# STAFF REPORT

**Case #21-27:** **SPECIAL PERMIT/  
157-161 Coggeshall Street**  
Map: 93 Lots: 168, 169, 275

Request by applicant for a **Special Permit** for the construction of a fast-food restaurant with a drive-through and associated site improvements at 157-161 Coggeshall Street (Map: 93 Lots: 168, 169, 275), a 0.8± acre site located in the Hicks-Logan-Sawyer Iterim Planning Overlay zoning district.

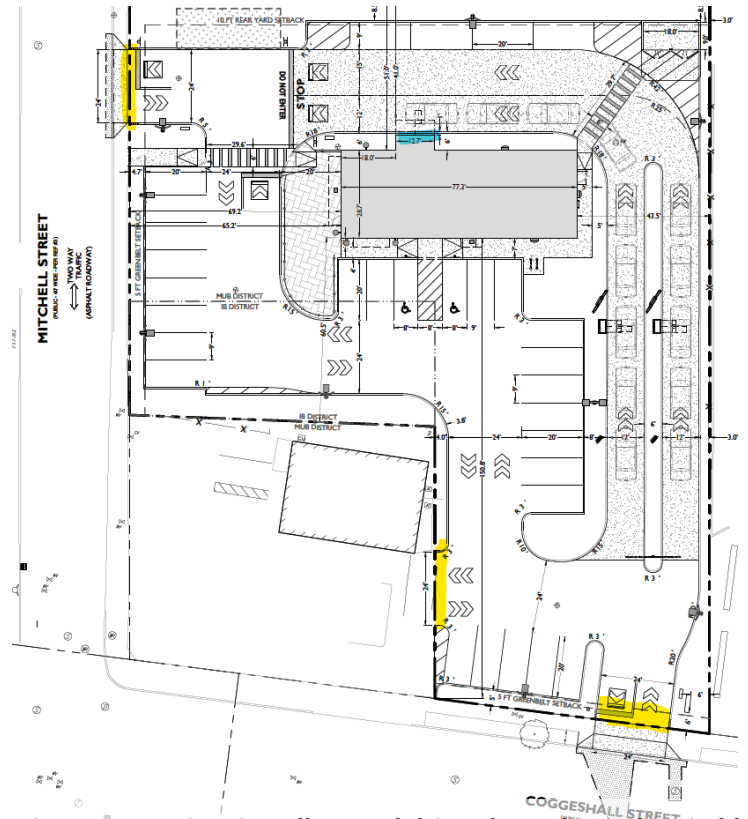
The traffic assessment also estimates decreases in the level of service for nearby intersections. In particular, the assessment predicts that the Coggeshall Street/Belleville Avenue intersection will decrease from a C to a D under both build and no-build conditions. The assessment also considers the impact on the Coggeshall Street/Mitchell Street intersection and finds B to a C for traffic turning right or left off Mitchell Street on to Coggeshall Street. The traffic assessment does not consider any other intersections in the area.

Pylon sign logo and signage.

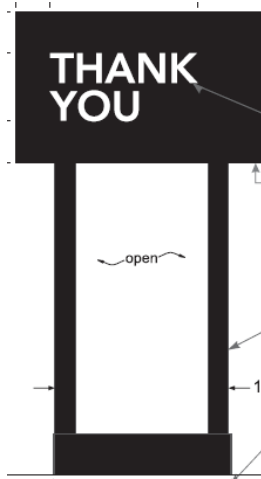
The applicant has provided a branding book that details the signage proposed for the site and building. The applicant proposes a pylon sign adjacent to the driveway entrance on Coggeshall Street with an overall height of 60 feet. The sign is topped by a 9' by 9' Starbucks logo and will be mounted on a steel tube. Sign plans indicate that the pylon specifics, including the height, are "TBD upon engineering." For reference, the Board restricted the height of ground signs for Riverside Landing Phase II to 37' in 2012, a decision that included the Taco Bell sign on Coggeshall Street and the Riverside Landing plaza gateway sign. **The Board may wish to discuss the details of the pylon with the applicant and condition a specific height.**
